DRB final sign-off SPSP ~~and~~ SPSP Amendment for overall watershed

RE: Del Webb, Phase III and IV – Project#1006864; Site Development Plans for Subdivision, 18EPC-40016 & 18EPC-40022

Project# 1006864
18EPC-40016 Site Development Plan
for Subdivision

Project# 1006864
18EPC-40022 Site Development Plan for Subdivision
Amendment

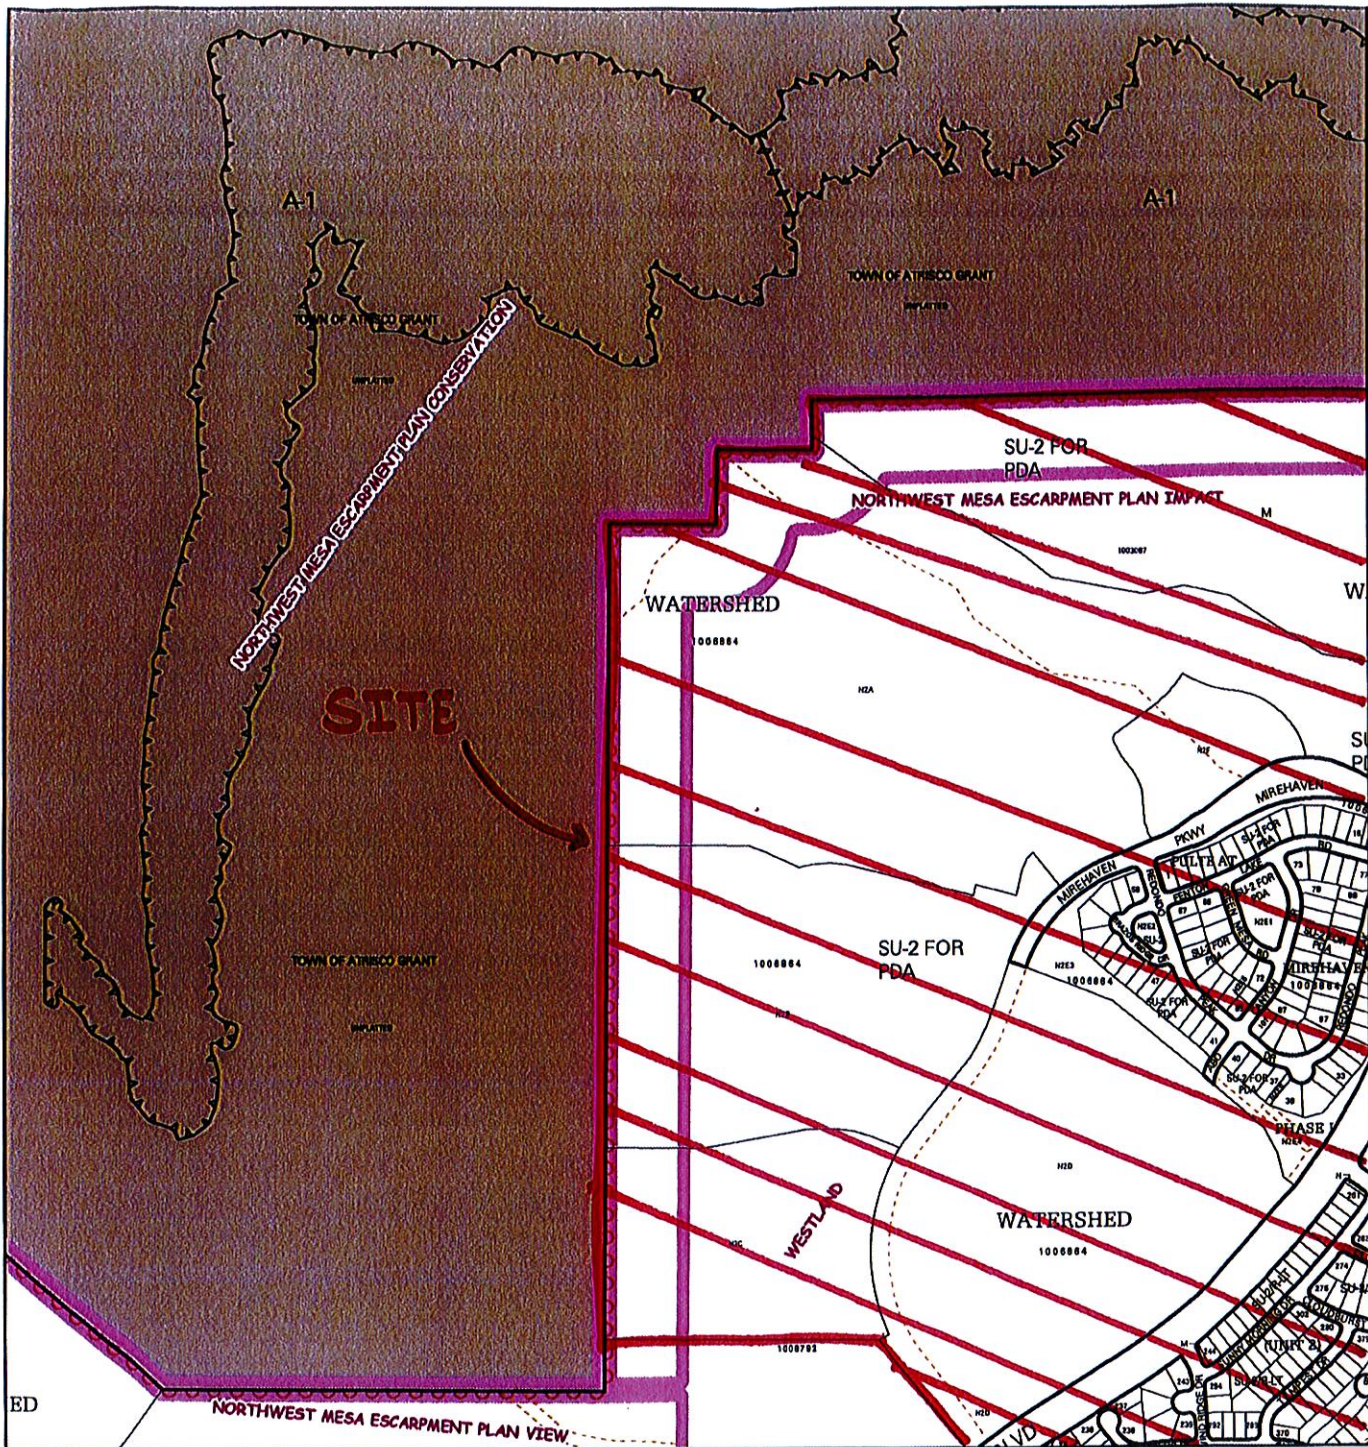
3. The access point for Tract N-2-B shown on the approved SPS dated 12-28-15 shall remain. The applicant can choose to have the gate remain or remove the gate.

The access point for Tract N-2-B has been added along with the gate on this Side Development Plan for Subdivision as well as the Del Webb Site Development Plan for Subdivision.
